IMPORTANT WARNING WHEN REPLACING A CONTROLLER ON OPxxx, OMAXI, OMINI

<https://diasys-technologies.com/waterpurifiers/> - **DiaSys Water Purifier Systems**

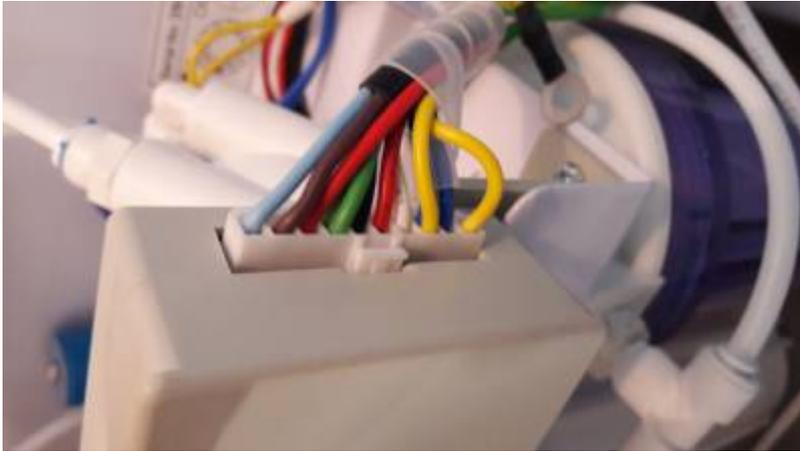
On some old osmosers, the cable bundle has no white wire on the 4th pin of the connector.

old cable bundle:

standard OPxxx, OMAXI, OMINI cable bundle:

ANY CABLE BUNDLE WITHOUT WHITE WIRE ON PIN 4 MUST BE REPLACED BEFORE CONNECTING A NEW CONTROLLER !!! (in such a case, the internal fuse will burn and the osmoser will not work)
